MACARTHUR TRANSIT VILLAGE PROJECT

Volume 4. Response to Comments Document
SCH No. 2006022075

Prepared for:
City of Oakland

May 2008

MacArthur Blvd at BART

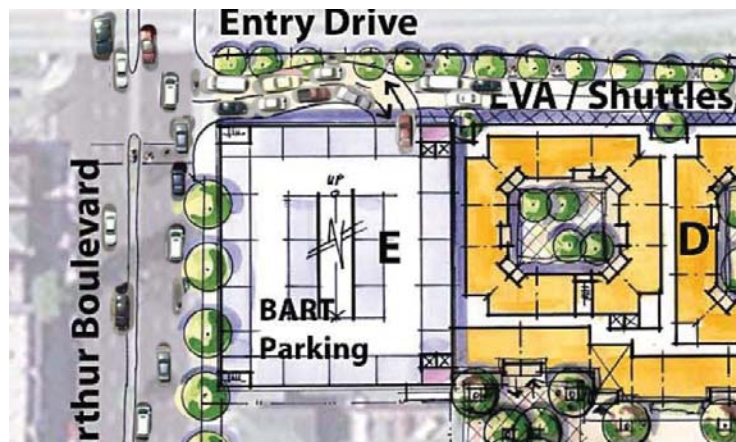
Just past the main pedestrian and bicycle entry to the MacArthur BART Station at 40th and Entry Drive, there is a "T" intersection at Entry Drive and the proposed new Village Drive. This intersection requires Entry Drive to become a two-way street from the Village Drive "T" to 40th St., which will decrease pedestrian, bicycle and motorist safety by increasing confusion and congestion where travelers are already in a hurry to catch their BART train. Kiss and ride drop off locations are also designed into the project along this short section. Village Drive should not have a vehicular connection to Entry Drive for normal traffic. Kiss & ride patrons should be dropped off and encouraged to walk from Village Drive or Telegraph to the BART Station and the two way section of Entry Drive should remain a one way entry as it is now. Bike parking should be convenient, adjacent to retail, and when possible covered.

Pedestrians and bicycles typically use the sidewalk along the west side of Entry Drive to access the BART station from MacArthur. Some bicyclists ride in the road the wrong direction to reach BART or the CalTrans Shuttle, as there is little traffic. There is no pedestrian crossing or left turn pocket at the MacArthur entrance and there is little vehicular traffic.

Figure 1: Modeled annual average concentrations of PM 2.5 from freeway sources at the Macarthur Transit Village

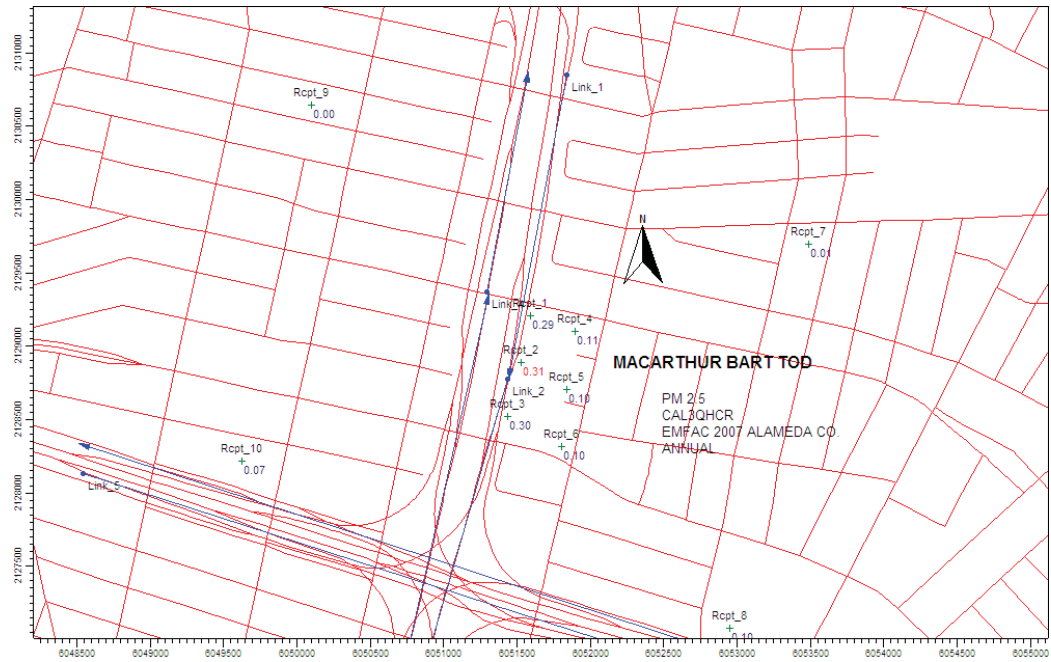
Figure 1 (attached below) illustrates estimated annual average freeway contributions to PM 2.5 concentrations at the Mac Arthur Bart Transit Village project site. Based upon the CAL3QHCR Line Source Dispersion Model Version 2.0, the maximum annual average contribution to PM 2.5 concentrations of from vehicles on major roadways at the project site was 0.31 micrograms per cubic meter. Figure 2 reflects the highest 24 hour concentration from freeway sources.

FIGURE IV.K-1

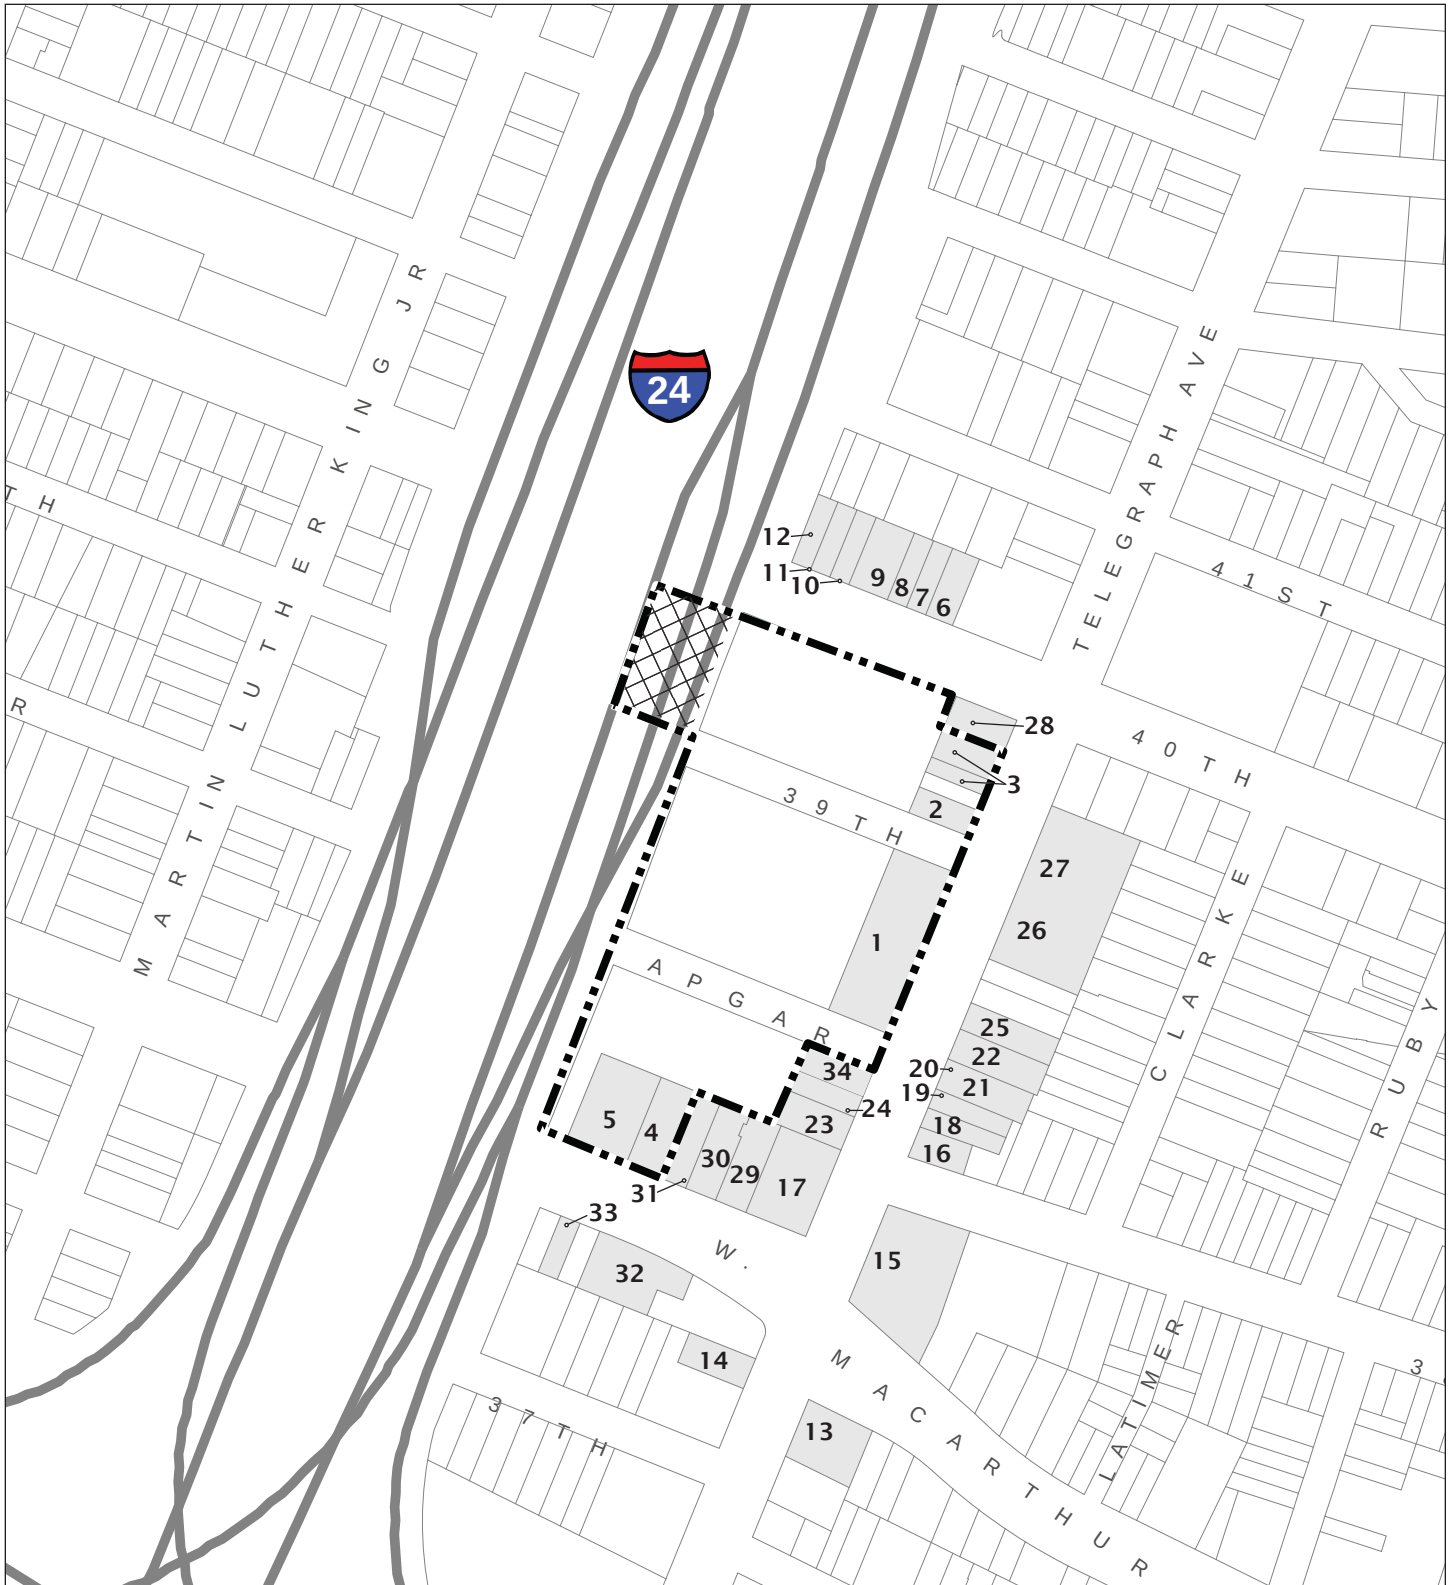
Page 411, Figure IV.K-1, has been revised as shown on the following page:
